South East Textiles (Pvt.) Ltd (Extension)

Gorai, Mirzapur, Tangail.
(24.094944, 90.166985)
05 March 2023

Observation: Store Shed

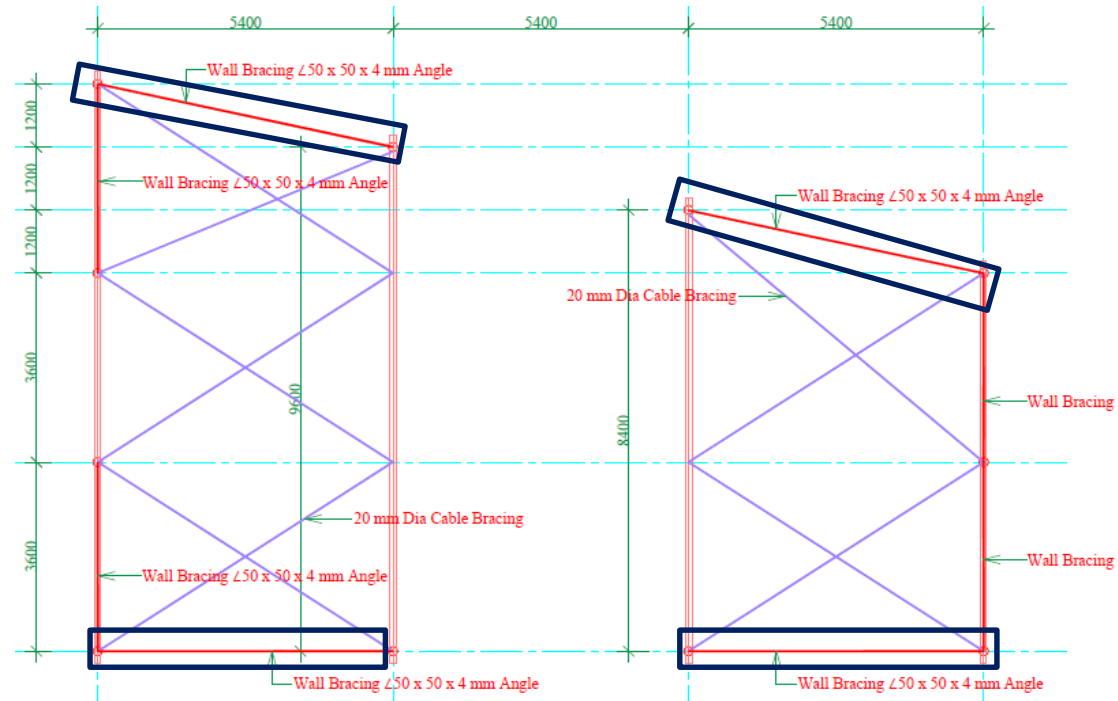
Apparently incomplete lateral stability system

No roof & wall bracing provided

Column support out of node

Bracing and lateral load transfer media was not observed in the structure. Also, poor connection between steel members were observed. Building engineer is required to check the lateral stability system of the structure and suggest necessary remedial actions accordingly.
